Subject: Product Safety Recall Bulletin 05052

L-Series Brake and/or Tail Lamps Inoperative

Models: 2000-2002 Saturn L-Series sedan vehicles and

2000-2004 L-Series wagon vehicles

1696946

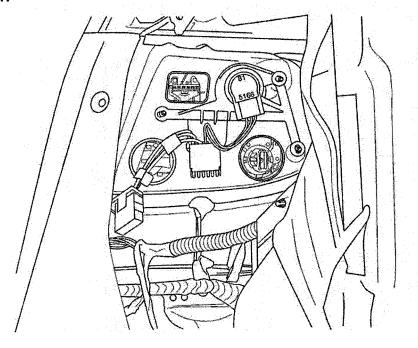
Important: There is a bracket assembly for the left and right tail lamp assembly. Each bracket assembly has a side indicator (1) on the face of the bracket assembly. Refer to the illustration to view the bracket assembly and the location of the side indicator.

- 3. Assemble and install the new bracket assembly.
  - 3.1 Install the bulb, P/N 12450108, into the socket in the bracket assembly.
  - 3.2 Position the bulb into the lamp assembly opening and slide the bracket over the three rear lamp studs.

3.3 Install the nuts to the tail lamp.

Tighten the nuts to 3.5 N·m (31 lb in).

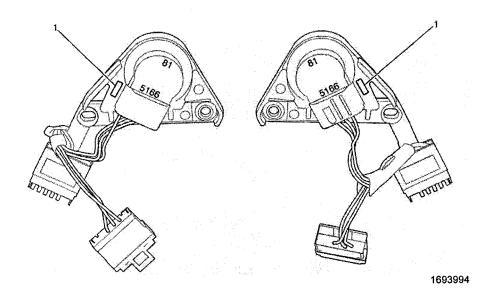
Important: There is a bracket assembly for the left and the right tail lamp assembly. Each bracket assembly has a side indicator (1) on the face of the bracket assembly. Refer to the illustration to view the bracket assembly and location of the side indicator.

- 3. Assemble and install the new bracket assembly.
  - 3.1 Install the bulb, PN 12450108, into the socket in the bracket assembly.
  - 3.2 Position the bulb into the lamp assembly opening and slide the bracket over the two lamp studs.
  - 3.3 Install the upper two nuts onto the tail lamp assembly, securing the bracket assembly.

Tighten the nuts to 3.5 N·m (31 lb in).
